09/973,133

Shunpei Yamazaki

Office Action Summary

FIG. 1B

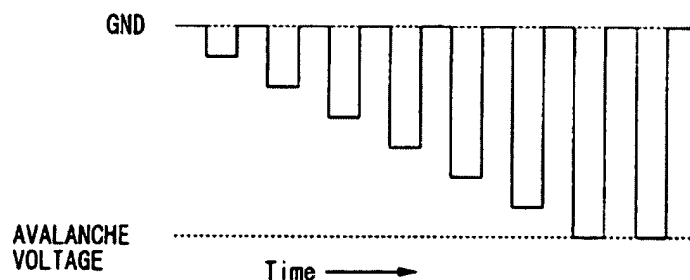
However, the examiner respectfully would like to point out (since applicants are relied on Fig. 1B for support of added claims) Fig. 1B of the instant application does not show either "a first voltage and a second voltage are alternatively applied between the anode and the cathode" or "a difference between the first voltage and the second voltage gradually increases with time." On the contrary, Fig. 1B of the instant application as depicted below shows the current flow between the ground and avalanche voltage.

Furthermore, the newly added limitations are included in the rejected claim as set forth in Paragraph 6 and anticipated by Tang et al. as disclosed in Fig. 4.
